October 27, 1993
LD-93-153

Subject: System 80+TM Information for Issue Closure

ASSESSMENT OF THE SYSTEM 80+ HYDROGEN
MITIGATION SYSTEM FOR APPLICATION IN A
SEVERE ACCIDENT ENVIRONMENT

Figure 3.1.5-1 (page 1 of 1)
Required Power Reduction After CEA Deviation

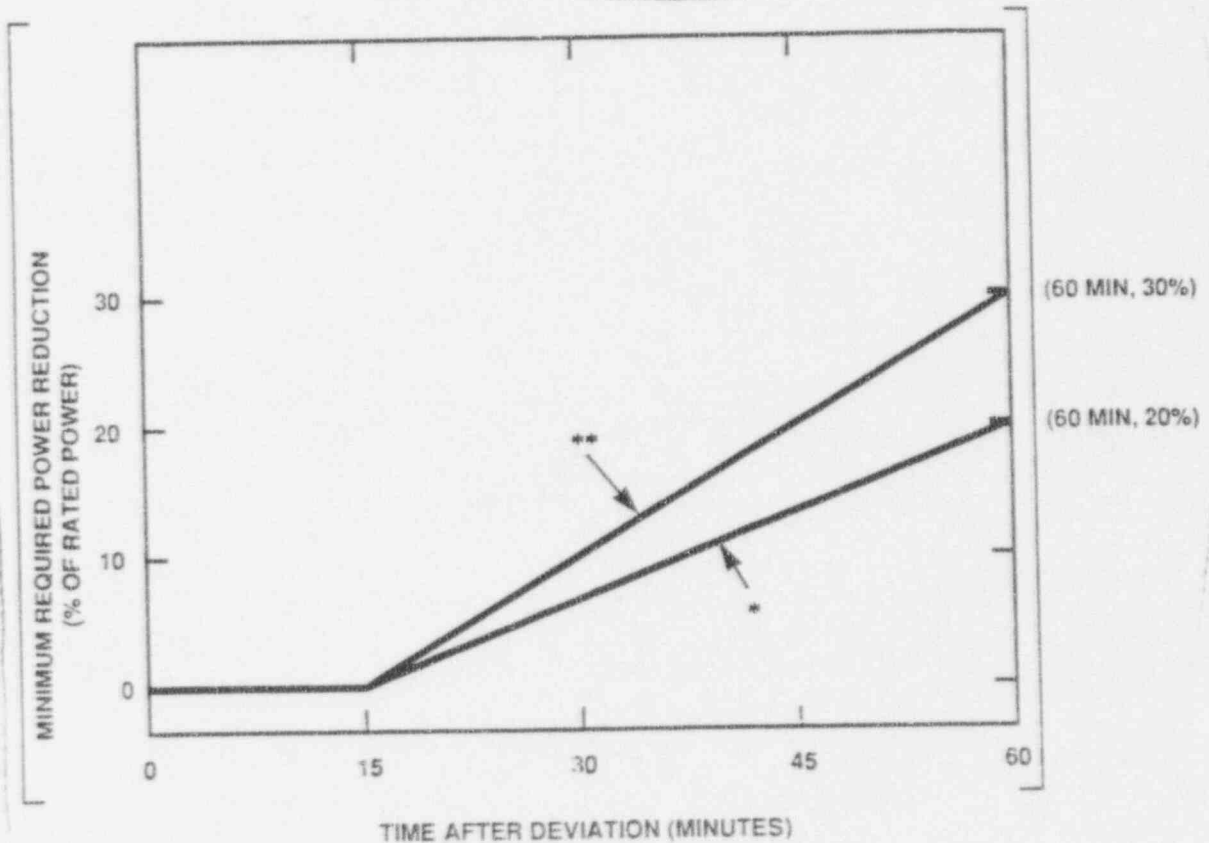
Xenon redistribution in the core starts to occur as soon as a CEA becomes misaligned. Reducing THERMAL POWER in accordance with Figure 3.1.5-1 (in the accompanying LCO) ensures acceptable power distributions are maintained (Ref. 6). For small misalignments ($<$ [19 inches]) of the CEAs, there is:

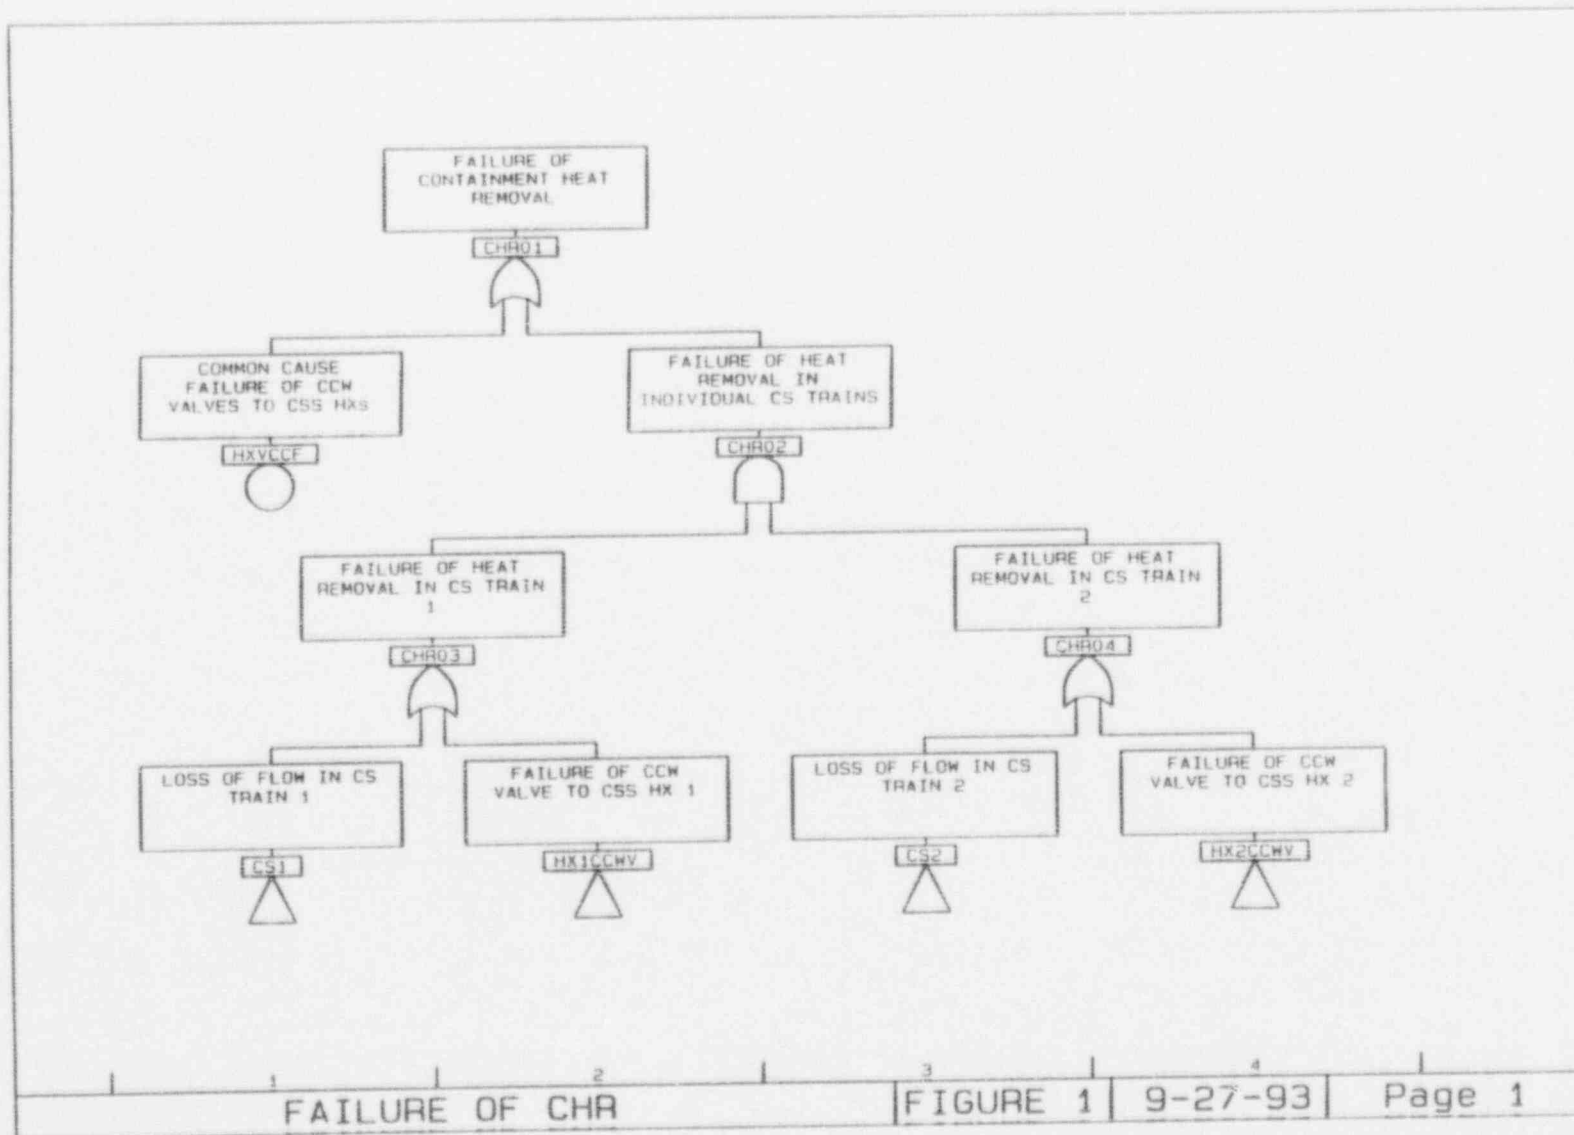
The unavailability of the Containment Spray System (CSS) is due to loss of containment heat removal or loss of containment spray flow. The results of the fault tree analysis presented in Section 19.6.3.13 indicate that the conditional failure probability for loss of containment heat removal given that the CSS has failed is approximately 41%. (This probability was obtained by summing the individual probabilities for the cutset that lead to loss of containment heat removal and then dividing by the total CSS failure probability. This includes common cause failure of the CCW containment spray heat exchanger outlet valves.) Conversely, the conditional failure probability for loss of containment spray given that CSS has failed is approximately 59%. It is therefore meaningless to compare these values with the values shown for the end states of the containment safeguard event tree.

The question regarding the failure probability of MOVs used in the Level 1 PRA pertains to the Rapid Depressurization Valves (RC-406, RC-407, RC-408, RC-409). These valves will be tested less frequently than other types of MOVs. Therefore, the failure probability for the RDVs was increased to reflect an 18 months test interval (Refer to Table 19.5-2, sheet 22 of 22). The failure probability for other types of MOVs, including the CCW containment spray outlet valves, will remain unchanged because these MOVs will be tested on a quarterly basis.

FIGURE 1
SYS80+ SBLOCA 1 SI PUMP COOLING
CLADDING SURFACE TEMP
NODE 21

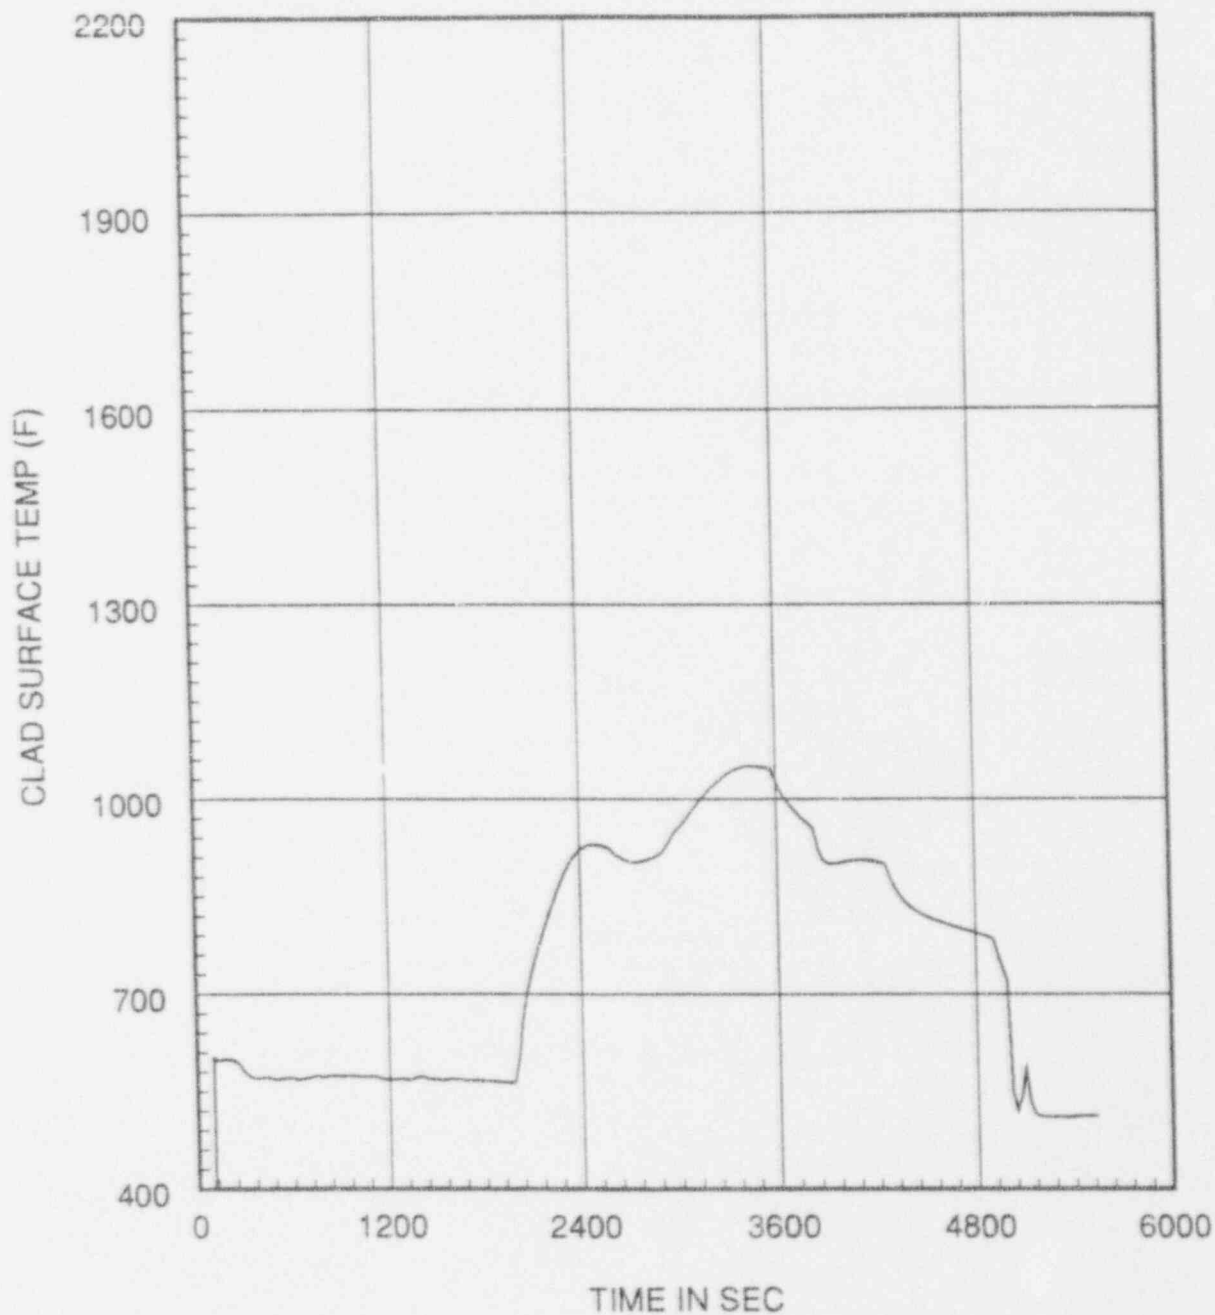
The cladding temperature transient for the hot spot (Node 21, 100% elevation from bottom of core) is shown in Figure 1. Figure 2 shows the cladding temperature transients for the nodes below the hot spot (Node 17, 80% elevation, Node 18, 85% elevation, Node 19, 90% elevation, and Node 20, 95% elevation). The core pressure, reactor vessel two-phase level, reactor vessel liquid mass, and the core power used as boundary conditions are shown in Figure 3.
